ADDENDUM 01

Date: April 24, 2026

Project: RFB-458 Fairmont State University Musick Library Modernization

NEW WORK - SECOND FLOOR
 PLAN - TECHNOLOGY

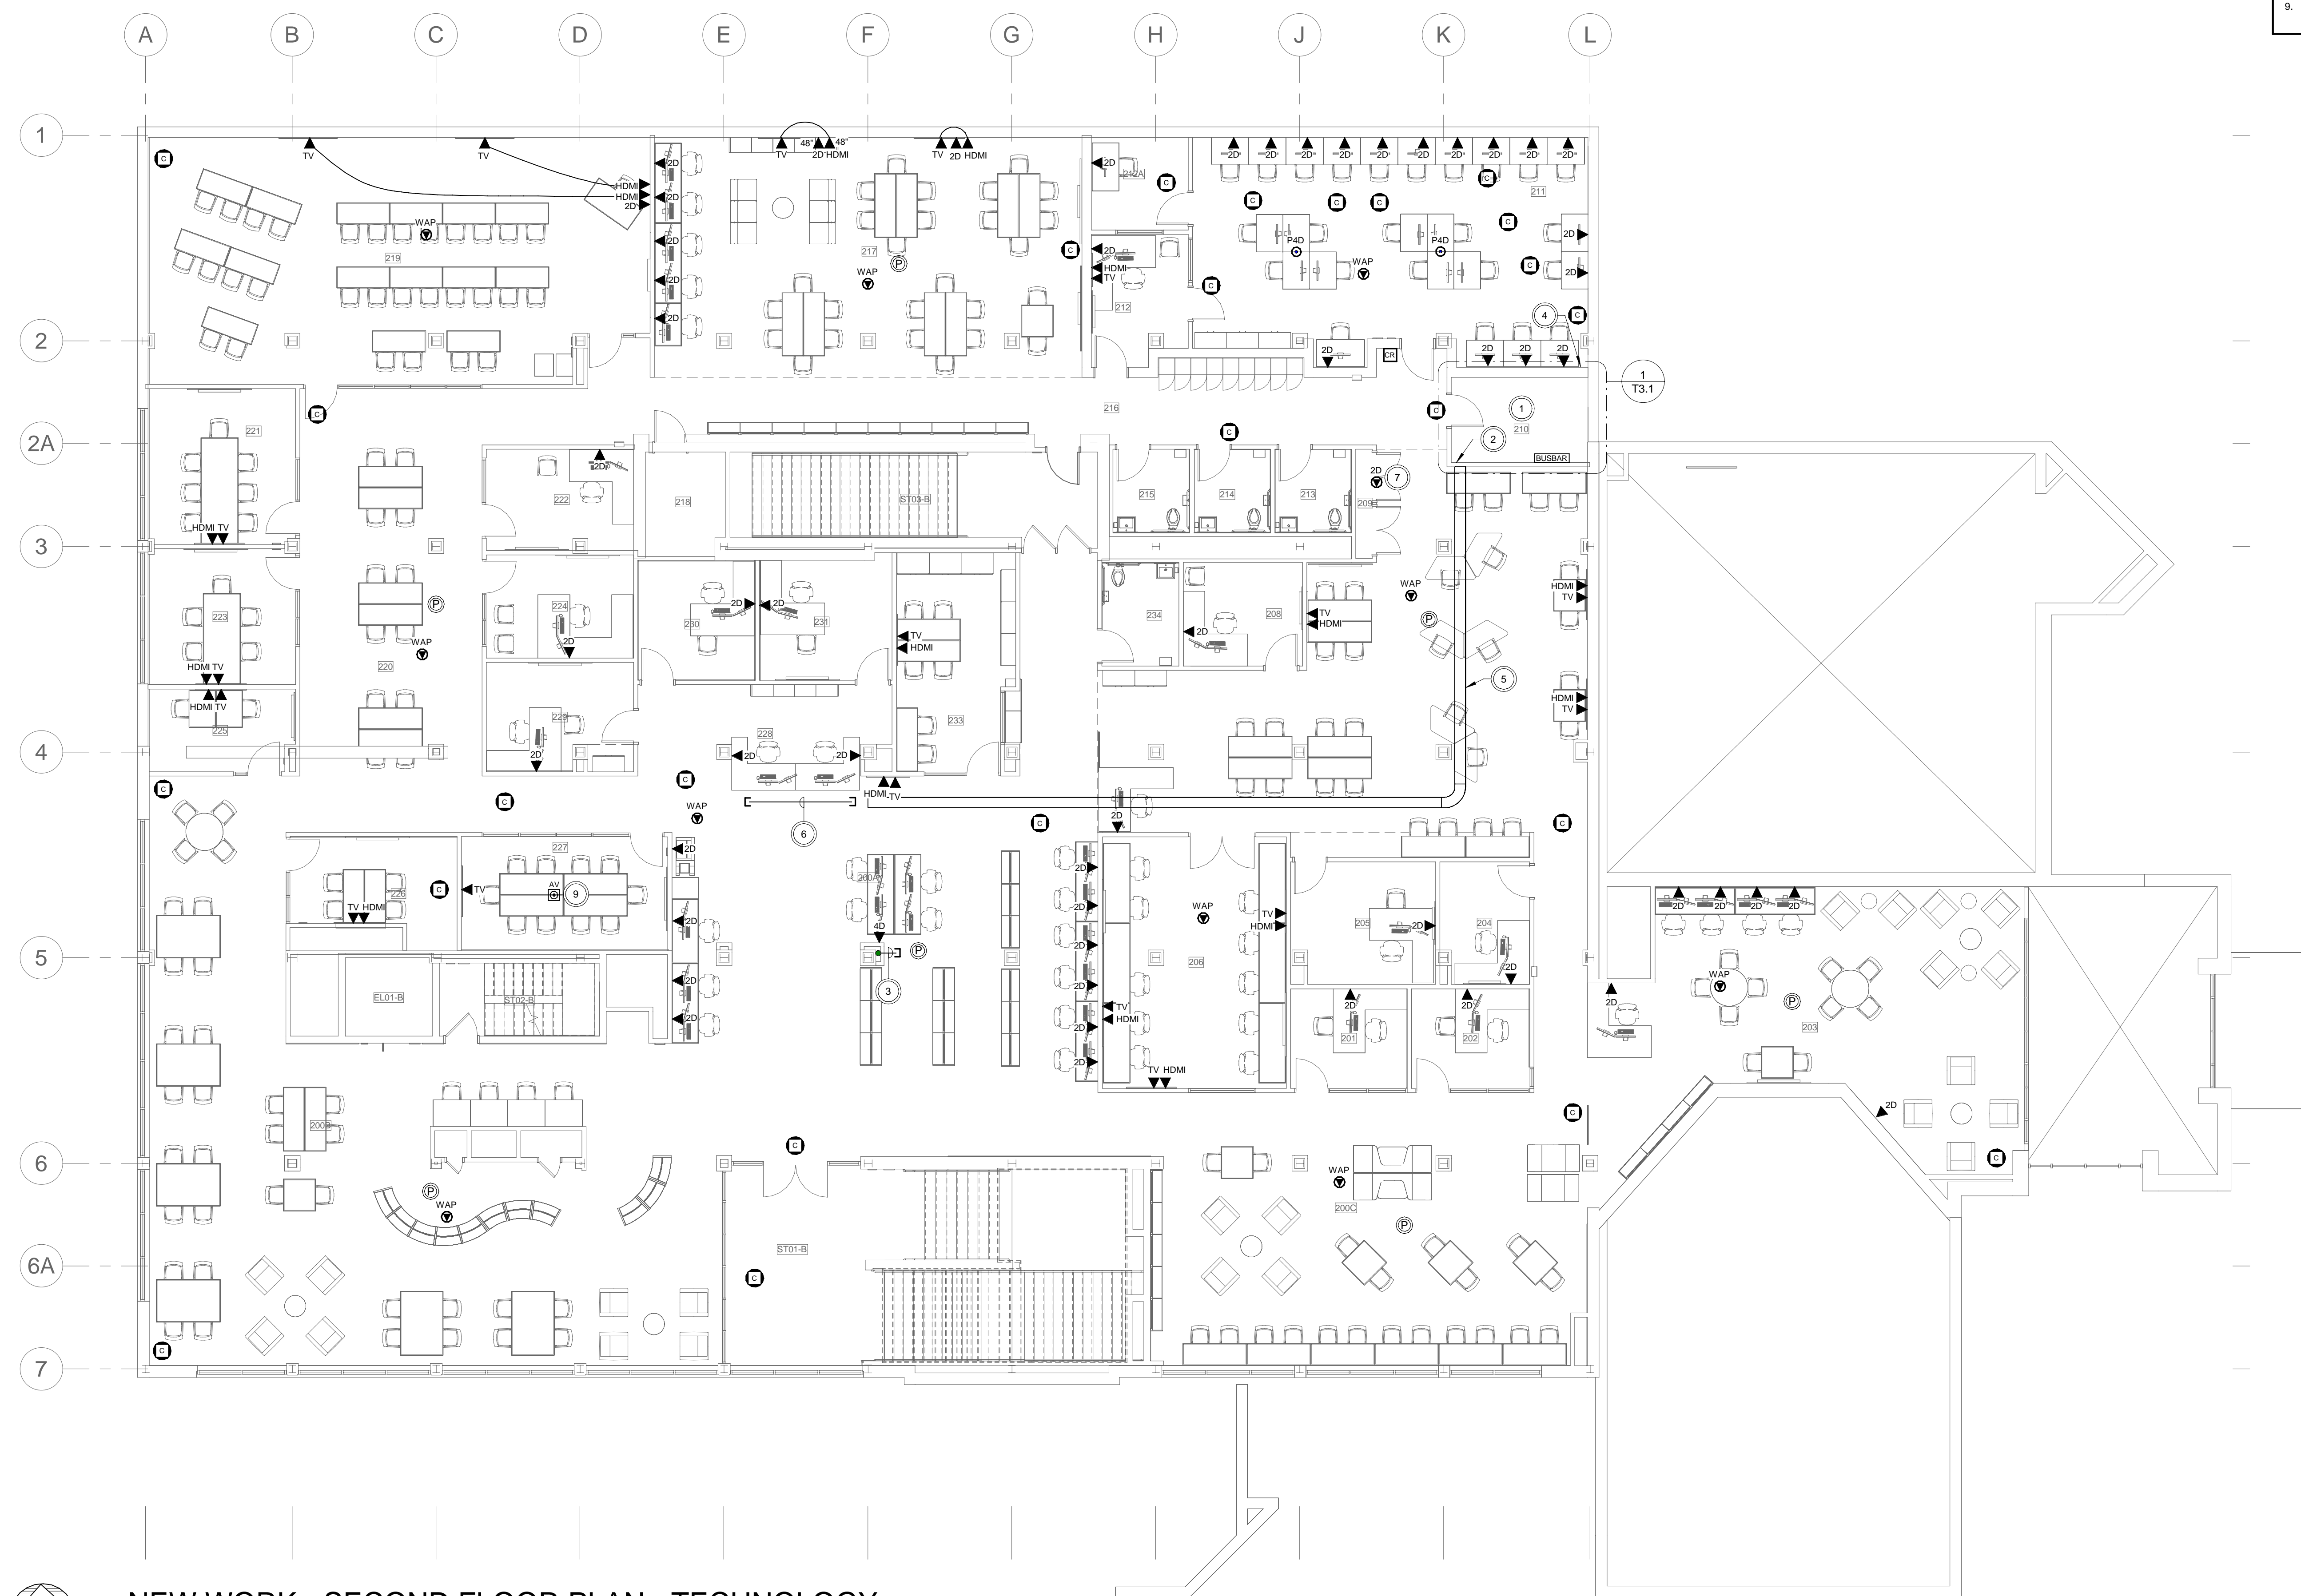
- a. Revisions to coded notes.
